**PREVOST**ENREGISTRÉ - REGISTERED
ISO 9001 & ISO 14001**WARRANTY
BULLETIN**

Wb11-09

DATE : MAY 2011	SECTION :	18 - Body
EXPIRATION: MAY 2013		
SUBJECT : REPLACING CONDENSER COMPARTMENT DOOR TWO HINGES

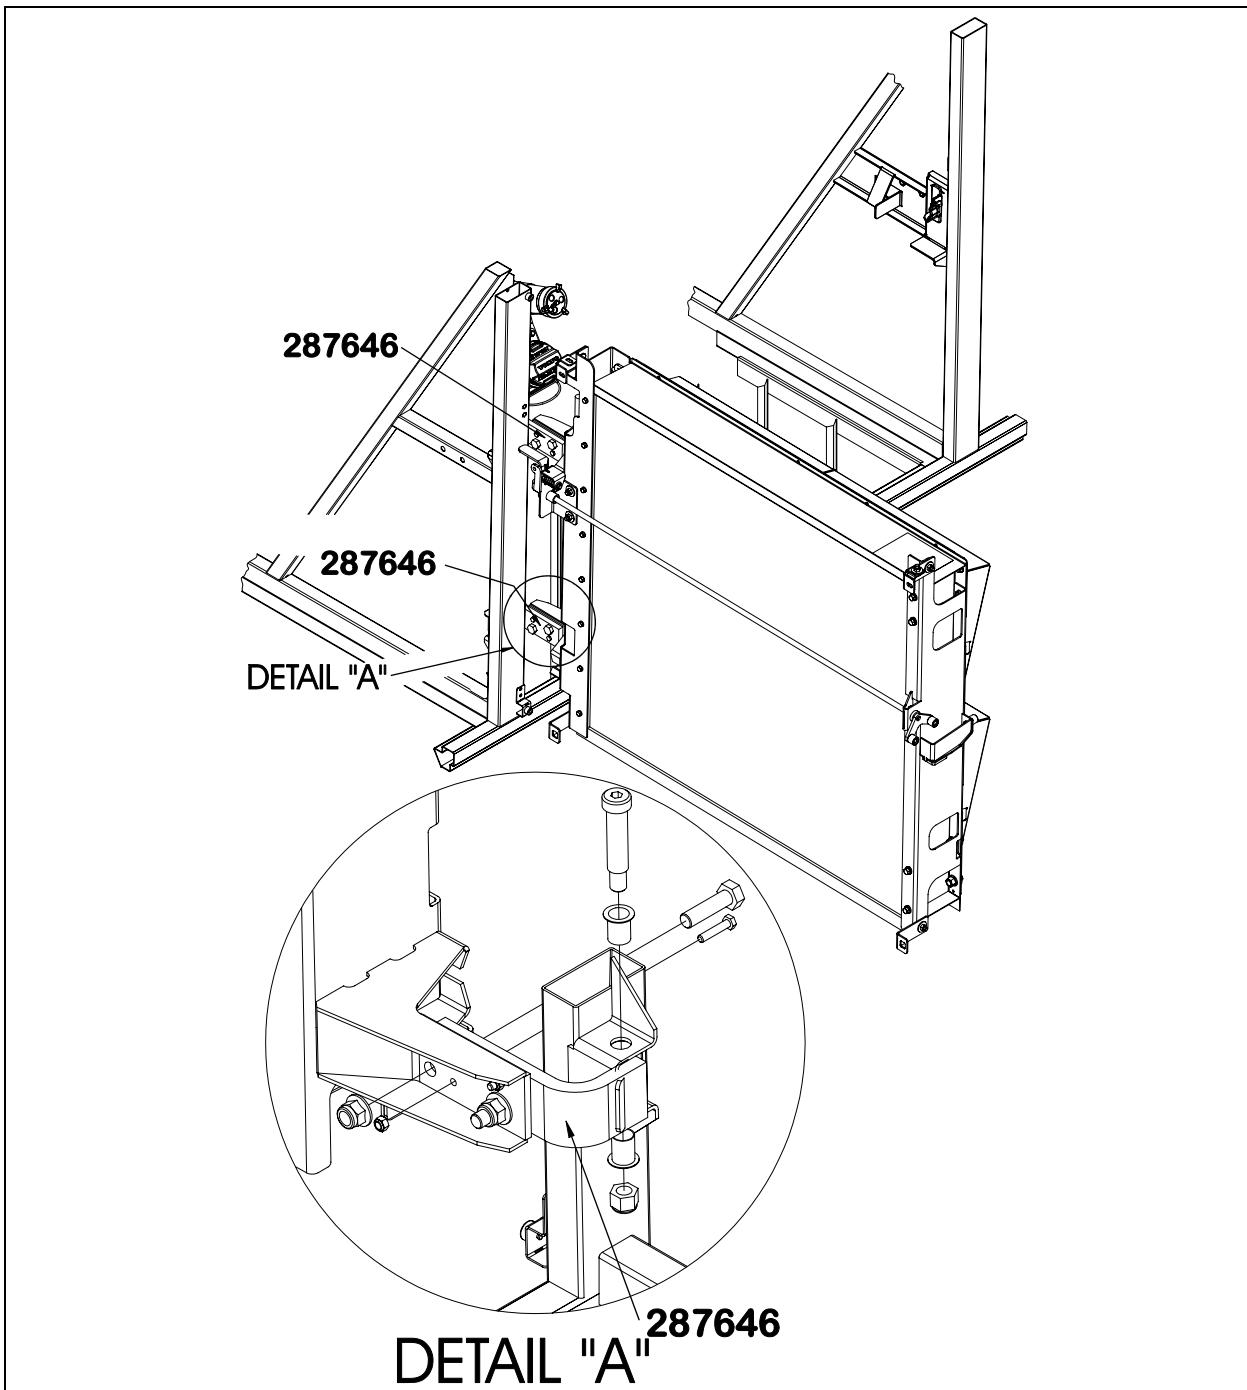
On the vehicles affected by this bulletin, there is a possibility that the condenser door hinge pivot weld be defective and result in breaking.

If breaking occurs when the door is opened, the condenser and door might fall down.

Part No.	Description	Qty
287646	Hinge, Condenser Door	2

3. Remove top hinge and replace with new part. Reinstall shims if applicable.

4. Remove bottom hinge and replace with new part. Reinstall shims if applicable.
5. Close condenser compartment door.
6. Check for proper operation of door hinges,
